Exhibit
Zoning Administrator Meaningful Connection Interpretations
Requiring Compliance with All Provisions Under B-309.1

**DEPARTMENT OF CONSUMER AND REGULATORY AFFAIRS
OFFICE OF THE ZONING ADMINISTRATOR**

Re: 1311 R Street NW - Square 0239; Lot 0129 (the "Property")

Re: 2800 16th Street NW (Square 2578, Lot 25) - Scottish Rite Temple

OVERALL SITE PLAN

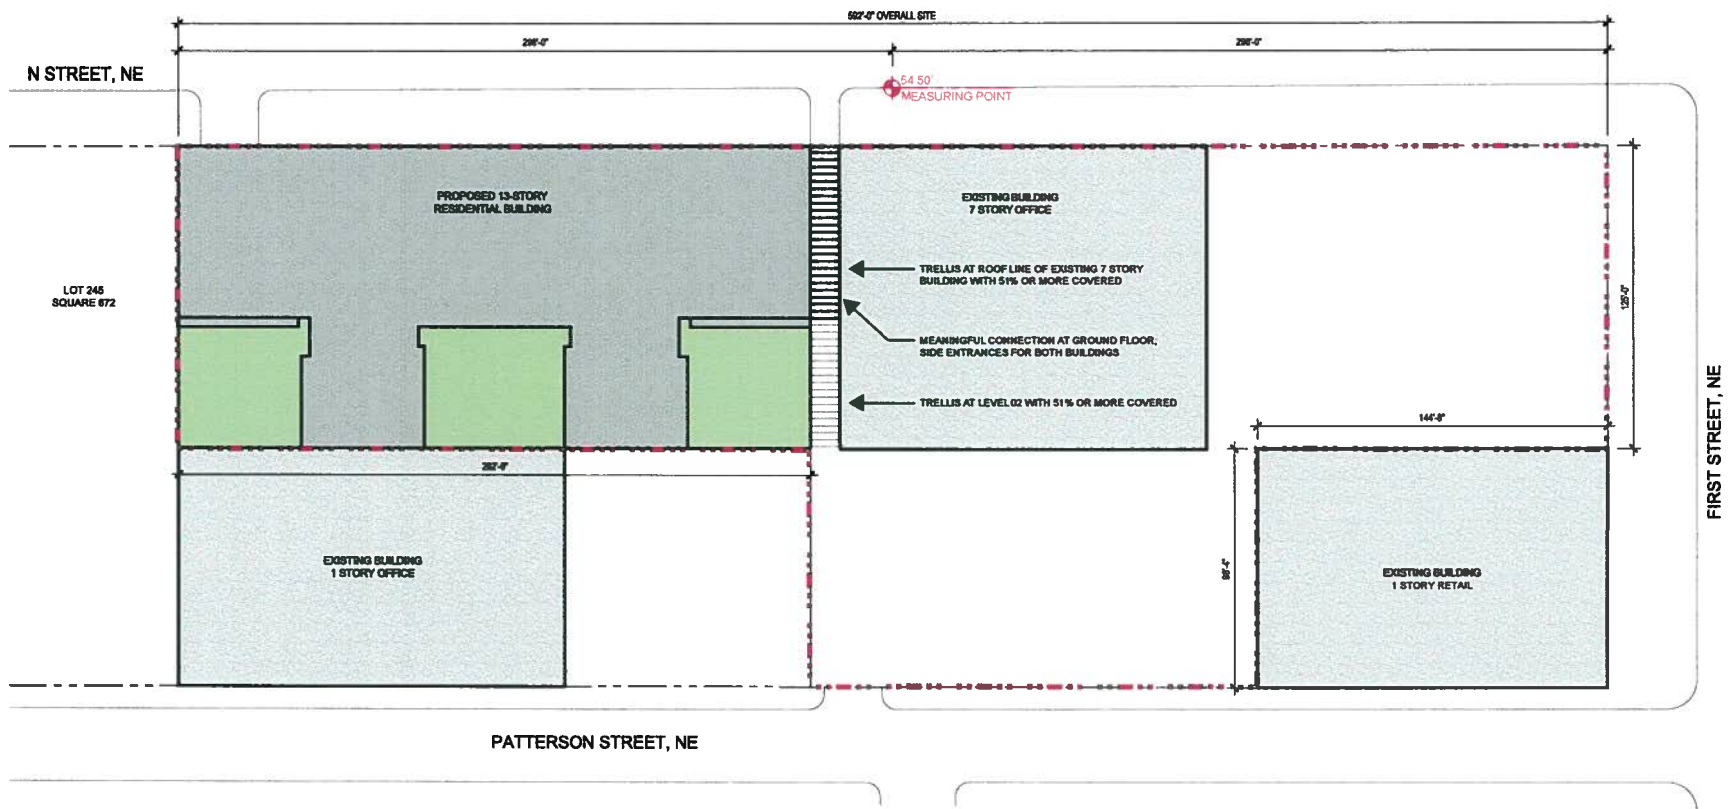
West Court: As shown on Sheet SD-03 of the Interim Court Plans, the West Court is a closed court and consists of a ground court, a lower court and an upper court.

Center Court: As shown on Sheet SD04 of the Interim Court Plans, the Center Court is a closed court and consists of a ground court and an upper court.

East Court: As shown on Sheet SD05 of the Interim Court Plans, the East Court consists of a ground court, which is a closed court, and an upper court, which is an open court.
